Council Reference: D25/148873  
Contact Person: Justin Lamerton

25 Moss Vale Rd Bomaderry – SSD- 69257218  
Shoalhaven City Council Response to Request for Comments

## **Development Engineering Comments / Requirements:**

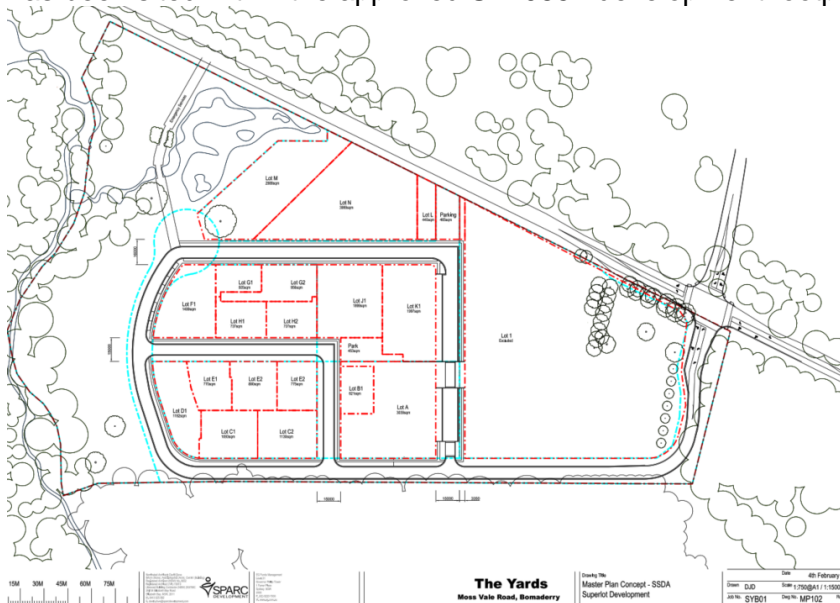
Based on the mapping provided, it appears that the proposed SSD-69257218 development footprint has been sited within the approved SF10851 development footprint. See snip below.

4. Based on the preliminary mapping provided, it appears that the proposed SSD-69257218 development footprint has been sited within the approved SF10851 development footprint (plan MP102). Council requests a revised plan showing the proposed SSD-69257218 Master Plan overlaid with the SF10851 development footprint, including:
  - a. a legend to clearly distinguish boundaries, and;
  - b. the land proposed to be dedicated to Council as a Public Reserve.
